# ASSESSMENT REPORT ON AVOIDING GREENHOUSE GAS EMISSIONS BY KEEPING FOOD IN THE HUMAN SUPPLY CHAIN

Document Prepared by Earthood Services Private Limited

<b>Methodology Title</b>	<i>Avoiding greenhouse gas emissions by keeping food in the human supply chain</i>
<b>Version</b>	1.0
<b>Methodology Category</b>	<i>Methodology: Yes</i>
	<i>Methodology Revision: No</i>
	<i>Module: No</i>
	<i>Tool: No</i>
<b>Sectoral Scope(s)</b>	<i>SS 13: Waste handling and disposal</i>
<b>Report Title</b>	<i>Assessment Report on Avoiding greenhouse gas emissions by keeping food in the human supply chain</i>
<b>Report Version</b>	1.0

<b>Client</b>	Verra
<b>Pages</b>	72
<b>Date of Issue</b>	01/11/2022
<b>Prepared By</b>	Earthood Services Private Limited
<b>Contact</b>	<p>Regd. Office: 409-410A, Tower B4, Spaze I-Tech Park, Sector 49, Sohna Road, Gurgaon-122018, INDIA</p> <p>Tel: +91 124 4204599</p> <p>Fax: +91 124 4204599</p> <p>Website: <a href="http://www.earthood.in">www.earthood.in</a></p> <p>Email: <a href="mailto:info@earthood.in">info@earthood.in</a></p>
<b>Approved By</b>	Dr. Kaviraj Singh
<b>Work Carried Out By</b>	<p>Team Leader: Shreya Garg</p> <p>Trainee Validator: Divij Varshney</p> <p>Tec

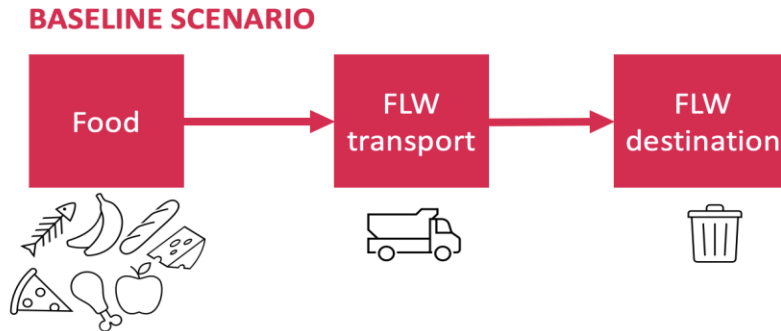
The provided figure is a clear and correct as well as appropriate delineation of typical project activities under the methodology.
